Structural Composites Industries

823D SERVICE BULLETIN 04 – 001 (12-6-04)
Pressure Relief Device (prd) Retrofit Instructions

**FIGURE I (NON-COMPLIANT)
ORIGINAL PRESSURE RELIEF DEVICE ASSEMBLY**

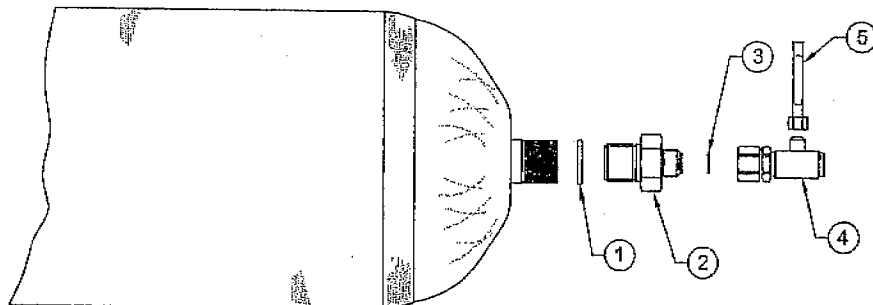
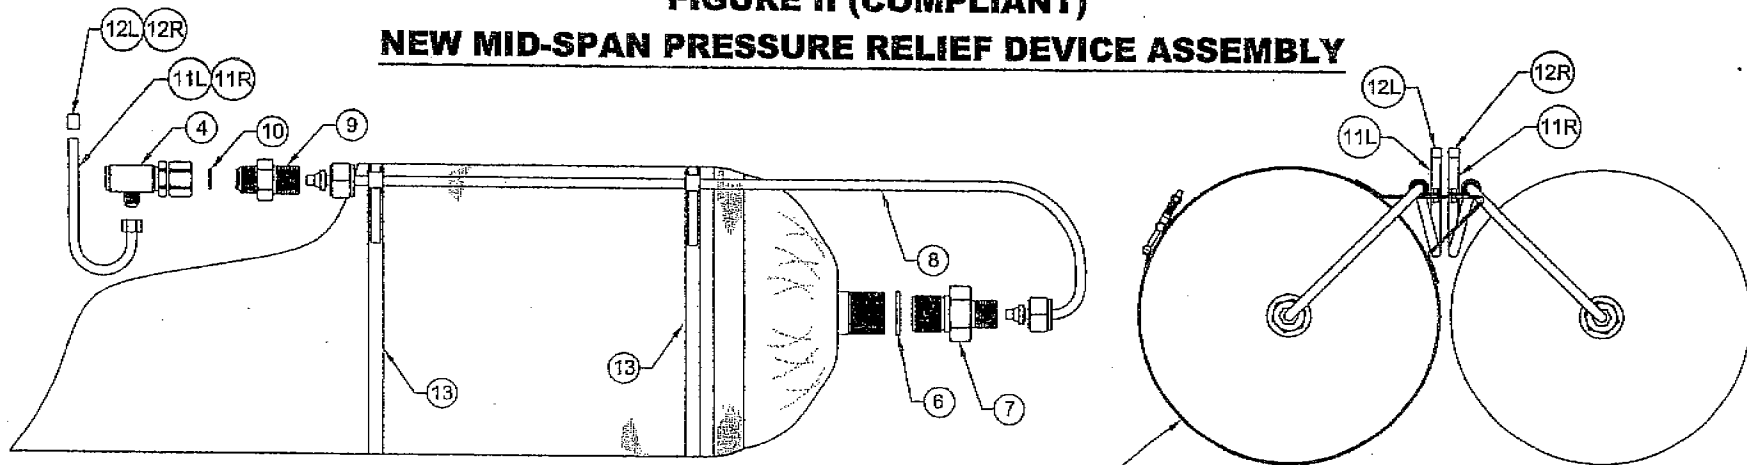
Referring to Figure I of Retrofit Schematic 1, the original (non-compliant) pressure relief device assembly consists of the original O-ring (1), tank-to-prd adapter (2), crushwasher (3), prd (4), and vent tube (5). After bus de-fueling, all of these items will be removed and only the original prd (4) and the rubber vent tube end cap will be saved. The other items should be discarded to avoid confusion with the new parts described in Step II.

Referring to Figure II of Retrofit Schematic 1, the new (compliant) mid-span prd system consists of a new O-ring (6), a tank-to-tube adapter (7), a high pressure tube (8), a tube-to-prd adapter (9), a new copper crushwasher (10), the original prd (4), a left hand vent tube (11L) with a color coded rubber cap (12L) or a right hand vent tube (11R) with a color coded rubber cap (12R), and a pair of mounting straps (13). The mounting straps are only placed on the four outboard tanks as shown in Figure II.

Referring to the tank end view of Figure II, the discharge ends of the left hand vent tubes (11L) and right hand vent tubes (11R) are designed to be aligned substantially vertical, parallel, and in close proximity with each other. The left hand vent tube will be installed on the left most tank in each tank row when viewed from the bus rear. The left hand vent tube will also be installed on the 3rd tank from the left in each tank row when viewed from the bus rear. At this point in the assembly process, uscrs can hand tighten an equal number of left hand vent tubes and right hand tubes onto the externally threaded prd discharge ports. To make this easier, SCI provided different colored rubber caps for the left and right vent tubes. Later, the vent tube caps will be replaced with the original rubber caps, and the vent tube positions will be adjusted so that only one vent hole must be drilled in the fuel system canopy for each pair of vent tubes.

Connect the tube-to-prd adapter (9) and the original prd (4) using the new crushwasher (10). TO AVOID LEAKS, it is critical that the crushwasher is centered within the inlet (nut end) of the prd so the crushwasher makes full, all-the-way-around contact with the pair of concentric seal rings on the end of the tube-to-prd adapter. To accomplish this, the prd should be placed in a vice with the prd inlet facing upward so the crushwasher can be placed in a centered position therein. Then hand tighten the tube-to-prd adapter down into the prd inlet to assure good all-around contact between the crushwasher and adapter seal rings. After hand tightening, the tube-to-prd adapter must be torqued to 50-55 Ft x Lbs.

Generously lubricate the new O-ring (6) with the O-ring lubricant (16) provided by SCI or with an equivalent lubricant suitable for use with Nitrile material. Place the O-ring onto the 1.125" threaded tank end of the tank-to-tube adapter (7). Torque the tank-to-tube adapter into the open tank port at 125-130 Ft x Lbs.

Similarly, thread the prd/vent tube/tube-to-prd adapter assembly into the pre-set nut at the other end of the high pressure tube, but only loosely at first. With the assembly loose on the high pressure tube, rotate the assembly so the discharge end of the vent tube (11a or 11b) can be positioned substantially vertical and parallel to the discharge end of the adjacent vent tube. Once the vent tubes are positioned, tighten the pre-set nut on the high pressure tube about 3/4 turn past hand tight, then back off the pre-set nut and inspect the ferrule for all-around contact with the beveled rim of the tube-to-prd adapter. Once good contact is confirmed, close and tighten the pre-set nut about 1/3 – 1/2 turn past hand tight. Finalize the vent tube so that its discharge end is substantially vertical as shown in Figure II and then tighten the vent tube compression nut about 1/2 turn past hand tight.

FIGURE III (COMPLIANT)
ITEM 13: RUBBER PADDED MOUNTING STRAP ASSEMBLY

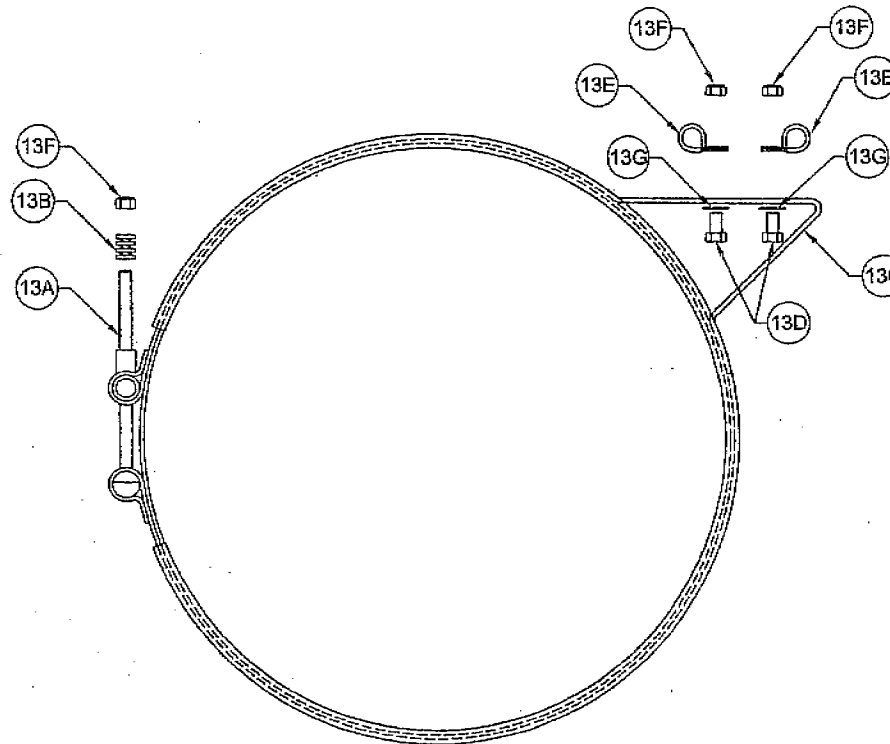
Place one mounting strap (13) around the outboard tank about 30 inches from the tank end. Rotate the mounting strap so the top edge of triangular tube shelf (13c) is horizontal as shown in Figure II. Referring now to Figure III of Retrofit Schematic 2, the mounting strap is secured onto the tank body by tightening the torque spring (13b) with the 7/16" lock nut (13f) on the mounting strap screw (13a). At this point, do not fully tighten the mounting strap so it can later be positioned within 1 inch of the tube-to-prd adapter. Likewise, place the second mounting strap about 2 inches from the tank shoulder and loosely secure it onto the flat cylindrical surface and not the tank dome end curvature.

Tighten the first mounting strap (13) around the tank at a position 1 inch away from the tube-to-prd adapter. Tighten the second mounting strap about 2 inches from the dome shoulder. The straps must be tightened so there will be no slippage of the strap across the tank surface.

Referring to Retrofit Schematic 2, secure the high pressure tube on the triangular tube shelf of the mounting straps with the hose clamps (13e), the locknuts (13f), washer (13g), and the #12 Hex Head bolt (13d). The hex head bolt and locknut must be tightened until they force the hose clamp flanges closed and into solid contact with the triangular tube shelf.
